GULF STATES UTILITIES COMPANY

River Bend Station - Unit 1
Docket No. 50-458

Enclosed for your review (Enclosure 2) are revisions to the River Bend Station Final Safety Analysis Report (FSAR) Section 6.2 and Appendix 6A. Enclosure 1 provides a discussion of each of these revisions including their effect, if any, on the Safety Evaluation Report. No revisions of the proposed Technical Specifications are expected to be required. These FSAR revisions will be included in a future amendment.

FIGURE A.6A.7-3

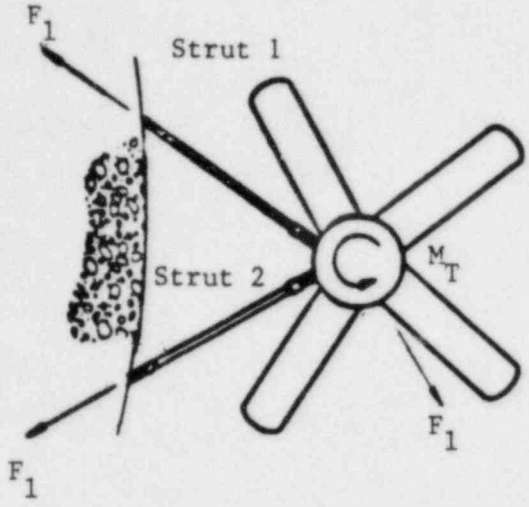
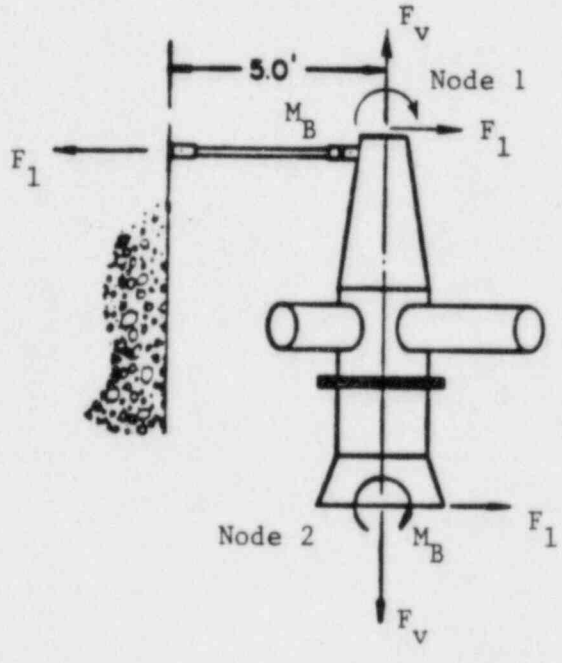
G. Information designated as "later" in Tables A.6A.7-1 and A.6A.7-2 and Figure A.6A.7-3 has been provided. This information is not expected to affect either the SER or the proposed Technical Specifications.

MAXIMUM QUENCHER ASSEMBLY REACTION LOADS AND MAXIMUM QUENCHER/SRVDL INTERFACE LOADS
(Reference Fig. A.6A.7-3)

Interface Loads (Node 1)	Reaction Loads (Node 2)	Strut 1	Strut 2
THERMAL				
F_l	6902	38736	28850	32241
F_v	10428	10428		
M_B	22323	324162		
M_T	8101	12793		
SRSS (OBET, OCCU)				
F_l	45286	63288	36778	40679
F_v	46561	181839		
M_B	17862	372324		
M_T	5019	105758		
SRSS (OBEI, OCCE)				
F_l	45346	77923	35045	39586
F_v	46454	181856		
M_B	19448	389493		
M_T	5738	107556		
SRSS (SSEI, OCCF)				
F_l	45357	77944	35063	39613
F_v	46460	181858		
M_B	19468	389852		
M_T	5768	107568
